Groundwater Application Review Summary Form

Application # G- 18423

GW Reviewer DENNIS ORLOWSKI Date Review Completed: 7/6/2017

TO: Water Rights Section Date 07/06/2017
 FROM: Groundwater Section Dennis Orlowski
Reviewer's Name
 SUBJECT: Application G- 18423 Supersedes review of _____
Date of Review(s)

Hunt 1999 Stream Depletion Model Results

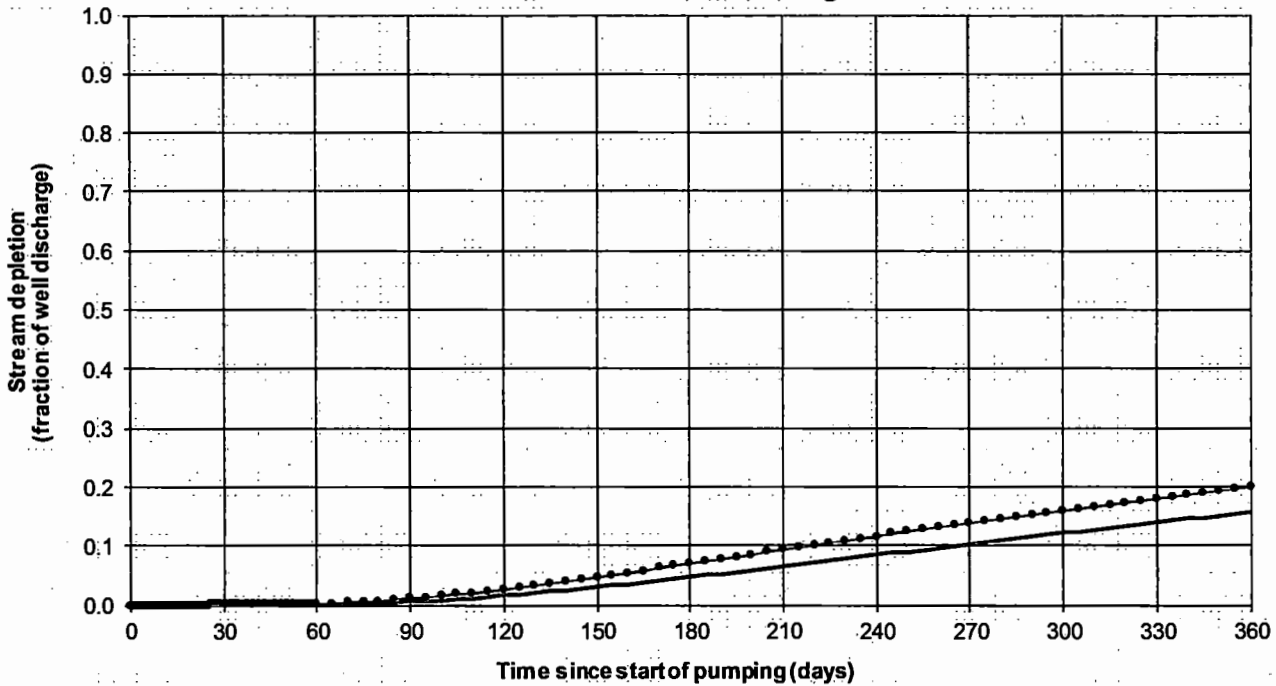
The Hunt 1999 stream depletion analytical model (Hunt, 1999) was used to estimate interference of SW1 (Columbia Slough) after one year of pumping the proposed POA at the maximum requested allocation. Using aquifer parameter values from applicable reports and from a pumping test conducted at nearby MULT 1222, the estimated monthly stream interference values are provided in Table C4a. However, because a WAB has not been established for SW1, pumping interference as a percentage of natural stream flow could not be evaluated.

C6. **SW / GW Remarks and Conditions:** As shown on Table C4a, pumping interference with waters of the Columbia Slough is expected to be very low within one year of continuous pumping. However, with additional time interference will increase until a new equilibrium between local recharge and discharge is reached, after which time stream depletion is expected to be relatively constant throughout the year.
